Contract No. T201606114.01 Federal Aid Project No. NH-N018(20) Main Street Newark Rehabilitation and Pedestrian Improvements New Castle County

Enclosed is Addendum No. 4 for the referenced contract consisting of the following:

Addendum No. 4 November 14, 2018

MAIN STREET NEWARK REHABILITATION AND PEDESTRIAN IMPROVEMENTS

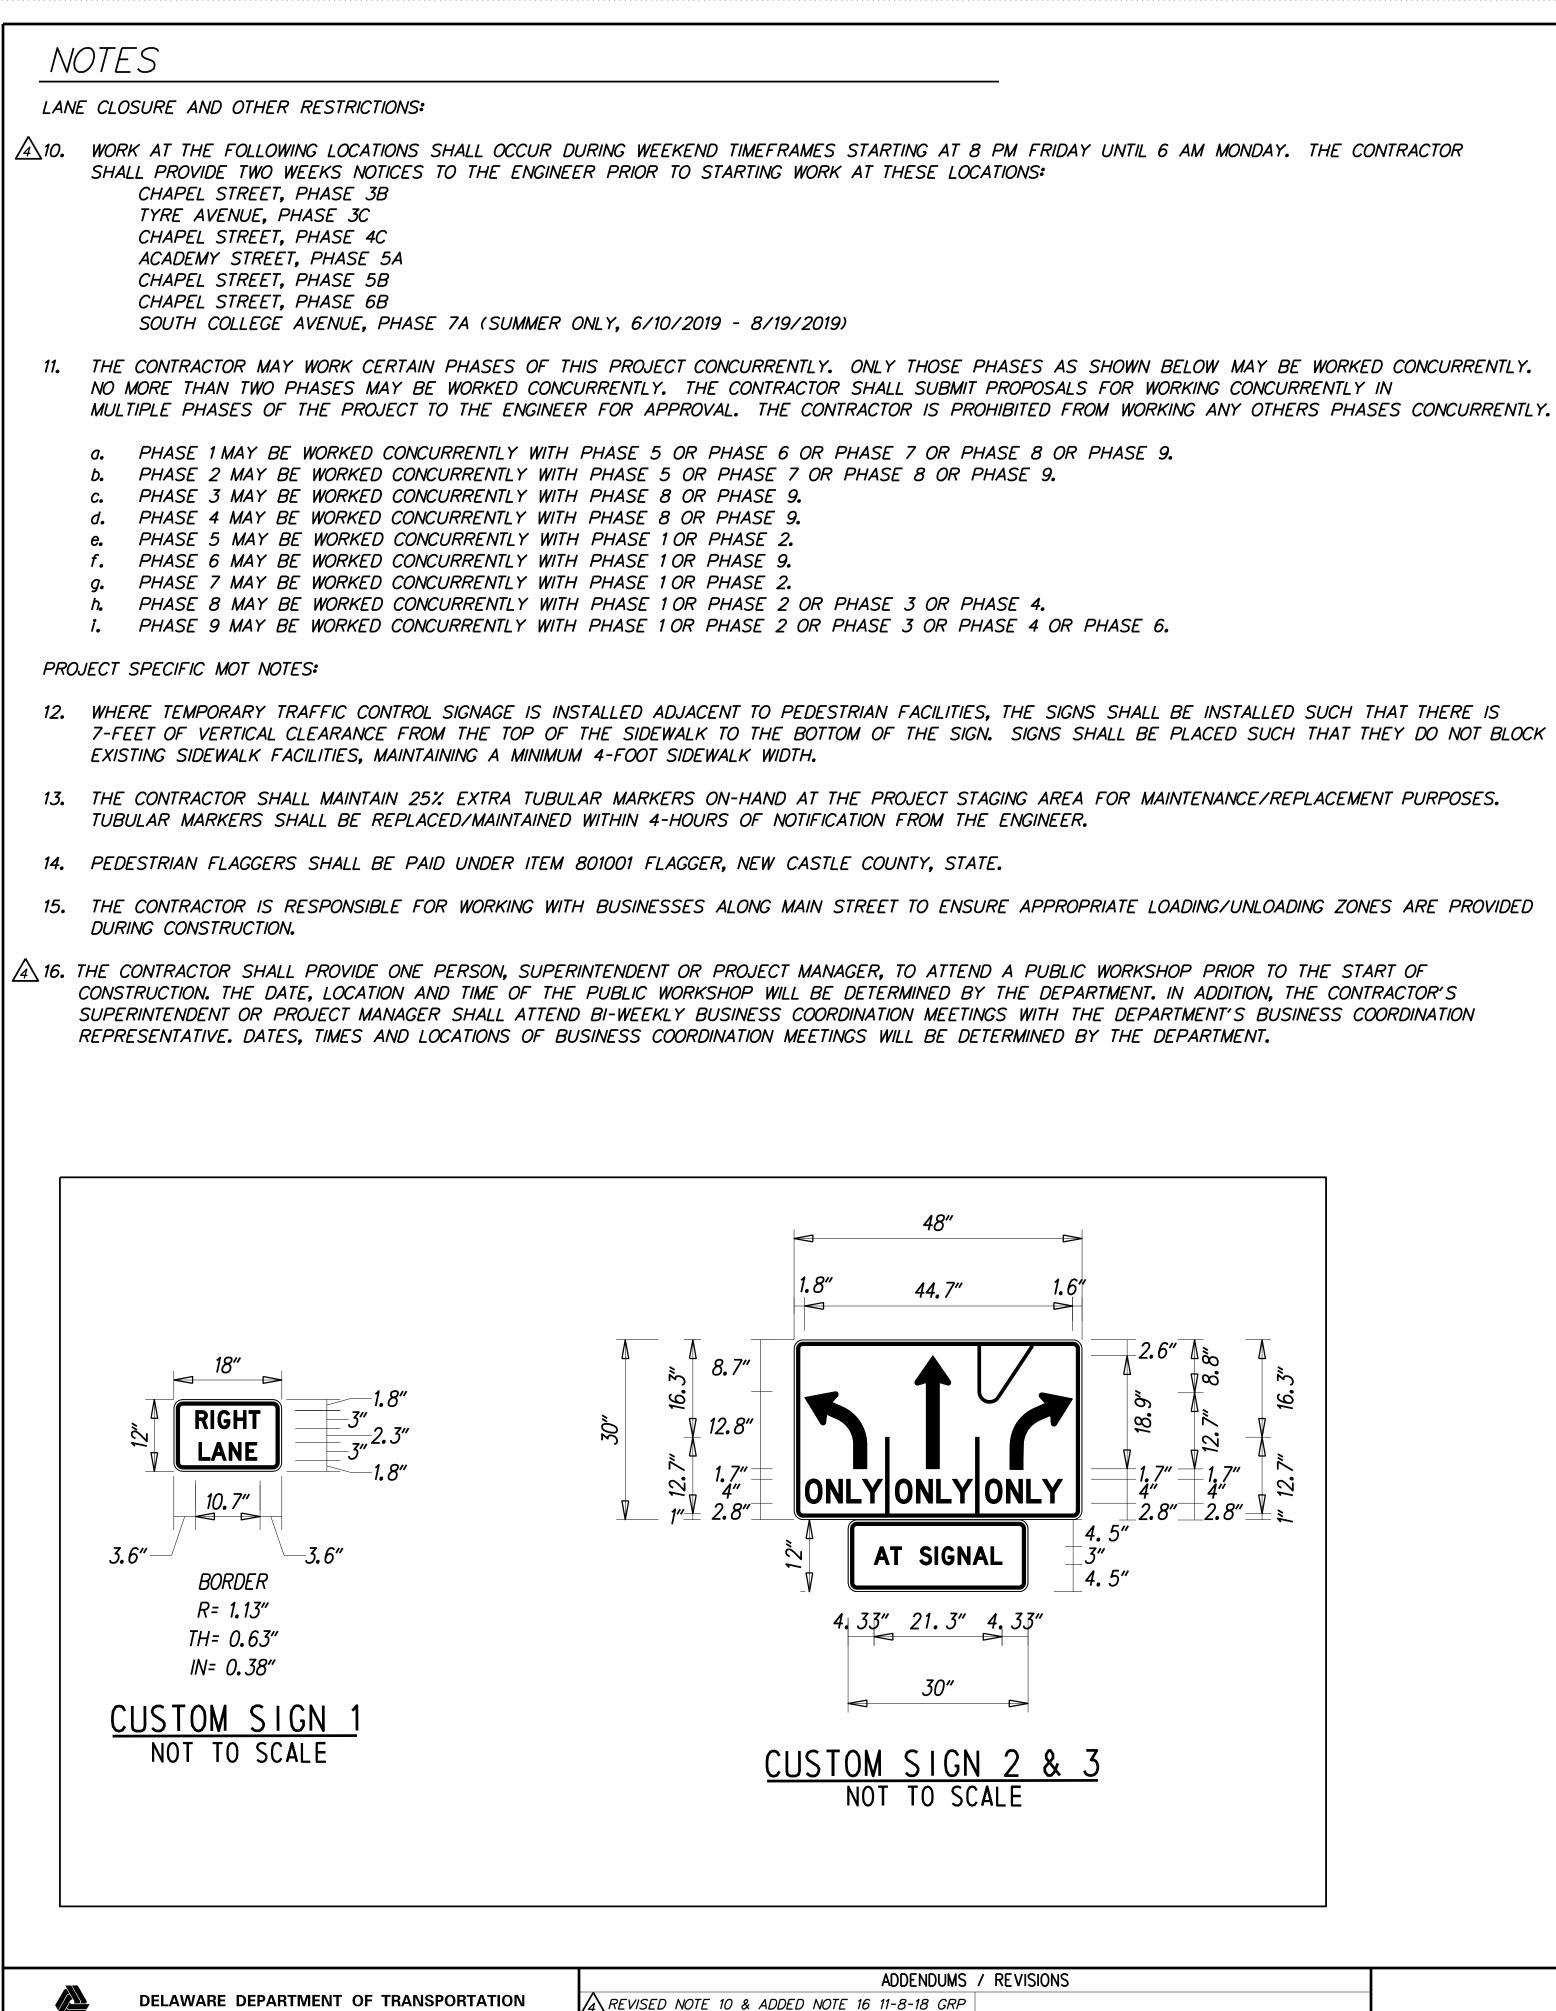
- ▲ 20. ANY PUMPING/DEWATERING REQUIRED ON THIS PROJECT WILL BE INCIDIENTAL TO ITEM 211001 REMOVAL OF PORTLAND CEMENT CONCRETE PAVEMENT, CURB, AND SIDEWALK. ALL PUMPING/DEWATERING OPERATIONS SHALL CONFIRM TO SECTION 902 - PUMPING OPERATIONS OF DELDOT STANDARD SPECIFICATIONS.

- A 21. CONTRACTOR IS REQUIRED TO USE ENGINEERING CONTROLS SUCH AS VACUUM DUST COLLECTION SYSTEMS AND WATER-DELIVERY SYSTEMS TO LIMIT EXPOSURE TO RESPIRABLE SILICA DUST. PAYMENT FOR ENGINEERING CONTROLS FOR SAWCUTTING WILL BE INCIDENTAL TO ITEM 762001.
